**July 3, 2024**

**City of Garden City  
Planning and Zoning**

**Re: DSRFY2024-0009 – Fenton Street**

DESIGN REVIEW COMMENTS

**WEST ELEVATION**

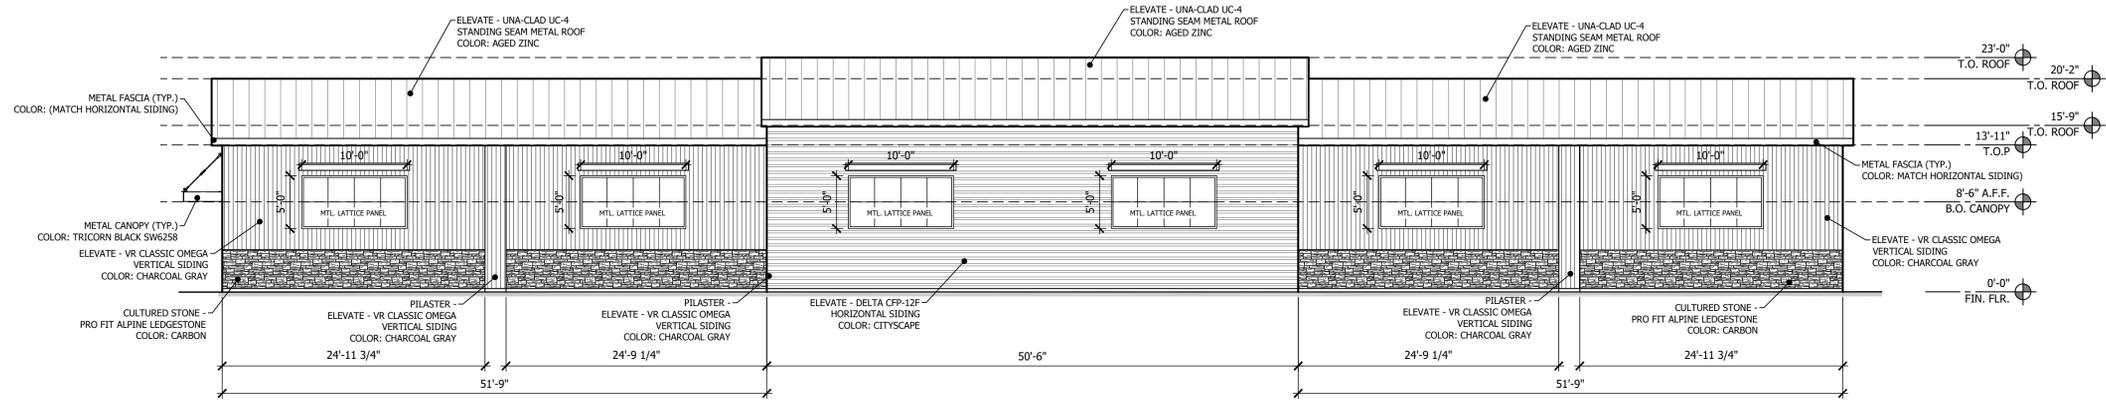
- **All walls contain at least 15% of windows or surface elements.**
- c. 6. Wall plane: Facades should have no wall plane wider than two and one-half (2 ½) times the height of the wall plane. There are (2) 154' wall planes that do not comply.

- **The building width was reduced by 2-feet, thus reducing the wall height along the westerly face. The north and south planes along the westerly side of the building are 51'-9", with a face height of 20'-7". The ratio of these faces are 2.5 : 1, excluding canopies and overhead doors. The center plane of the westerly wall is 50'-2" wide x 23'-2" height, with a ratio of 2.18 : 1. The center section of the building was further extended to the east by 1-foot, effectively dividing the 154' wall plan into 3 separate planes. The easterly and westerly wall now meets 8-4C-3 criteria.**

**EAST ELEVATION**

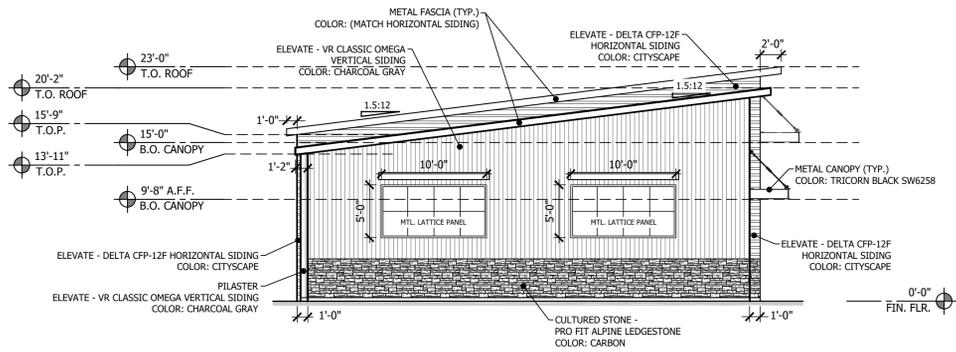
- The east and north elevations contain blank walls. Any blank walls should be treated in one or more ways:
  - a. Installing a vertical trellis in front of the wall with climbing vines or plant materials; or
  - b. Providing a landscaped planting bed at least five feet (5') wide or raised planter bed at least two feet (2') high and three feet (3') wide in front of the wall, with plant materials

2. This building appears to be a pre-engineered metal building due to the lack of articulation. Measures should be taken to lessen the appearance of being a prefabricated structure.

- **The north and east walls have been revised to contain trellis panels along each of the wall faces to provide additional relief. The landscape design has also been revised to contain taller vegetation along the faces of the building to provide screening to at least 50% of the surface.**

- **The east wall is adjacent and within 10-feet of an existing metal shop building with a blank wall containing wall mounted HVAC equipment, with no openings, windows or doors. The addition of lattice panels and taller landscape planting along the face of the proposed building will provide the appropriate screening and buffering required per code.**

- **Pilasters have been added along the east face of the building and the center section has been increased 1-foot to provide articulation to the building plane to mirror the westerly face. Also, additional metal lattice panels have been added to provide more interest to the adjacent property owner. With the two different roof planes and articulation of the north and south ends of the building, the structure gives less of an appearance of a rectangular, constant low pitch gabled prefabricated building. This structure will not have the appearance of a prefabricated metal building with the use of vertical and horizontal siding that provides deeper shadow lines and relief to the face of the structure.**

**SOUTH ELEVATION**

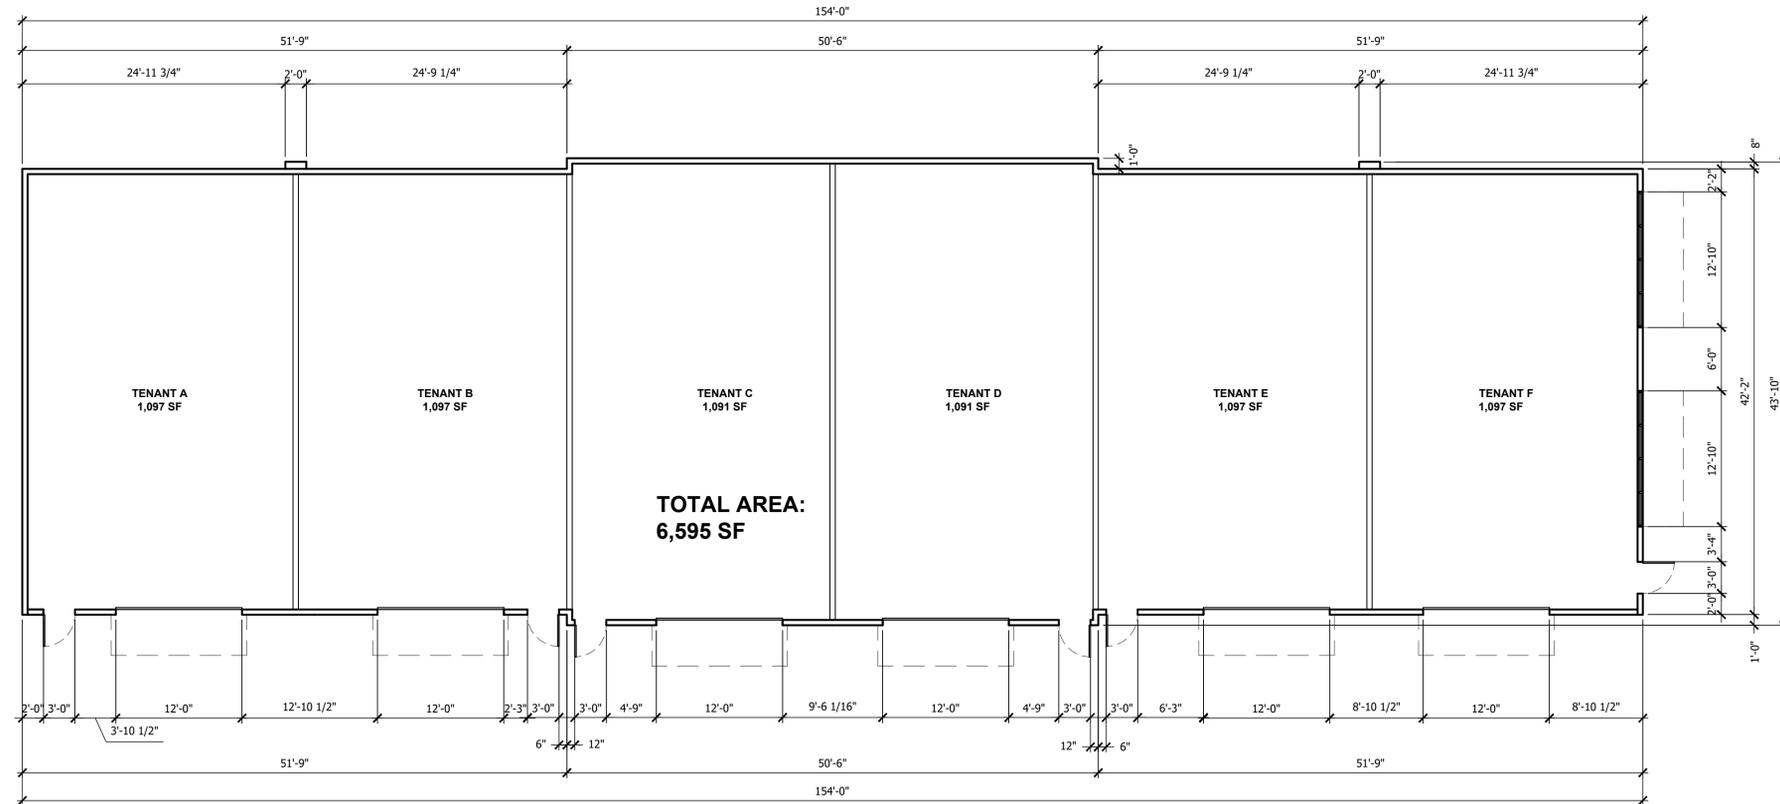
- South elevation faces Fenton St. The renderings and schematic drawings do not match. All primary entrances face the internal parking lot, Tenant space F does not have a primary entrance facing the street.

- **The entrance on the south side of the building, Tenant space F, has been relocated to face Fenton Street. This entrance will have a canopy and enlarged entry space, providing a clear entry place of entry to the public from the street.**

L1.0

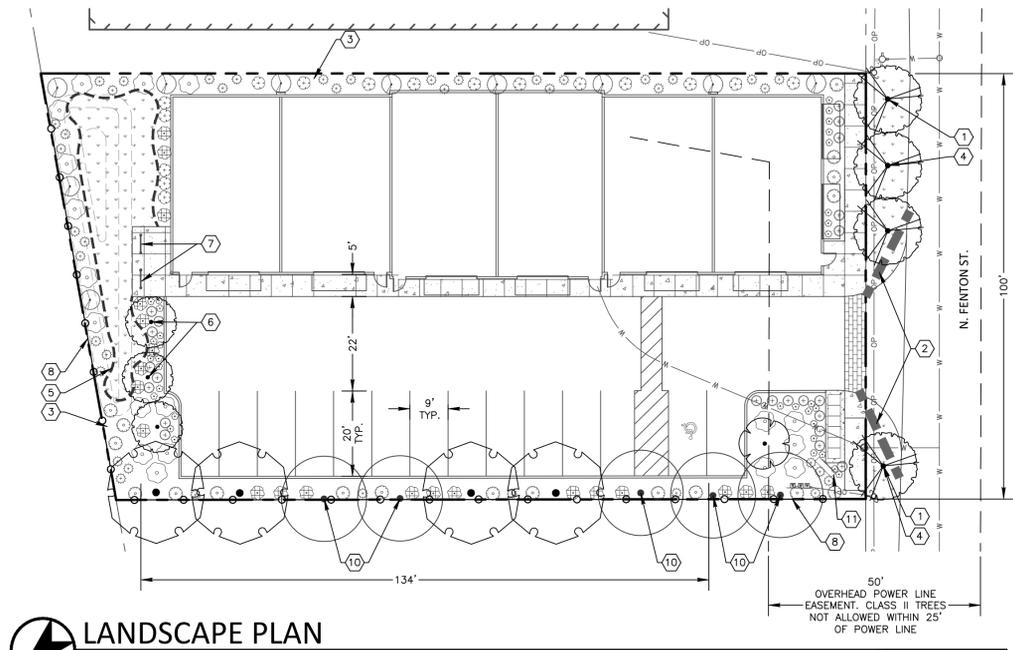
- This application does not request use(s) for the tenant spaces. Therefore, parking requirement calculations are based on the highest standard of 1 per 500 sqft. of gross floor area.
- Bike parking requirements are calculated at the same ratio. 14 bike parking spaces are required, but only 7 are provided. The site is lacking 7 bike spaces.
- **The site plan has been revised to include a total of 14 bike spaces.**

- A minimum of five percent (5%) of the gross site shall be landscaped areas, excluding areas for setback or perimeter landscaping.
- **Per Interior landscape Requirements on sheet L1.0, the gross area of landscaping will be 8.76%.**
- A minimum of one class III tree shall be planted in the frontage and every adjacent streetside. An additional class 1 tree shall be planted in the corresponding setback for every increment of fifty feet (50') of linear feet of frontage.
- Provided: 2 class II trees (deficient 1 tree)
- **The Landscape plan has been revised to comply with this section of code.**

CALCULATIONS	REQ	PRVD
6,876 SF / 500	14	14
<b>BICYCLE PARKING SPACE TOTAL</b>		
	14	14
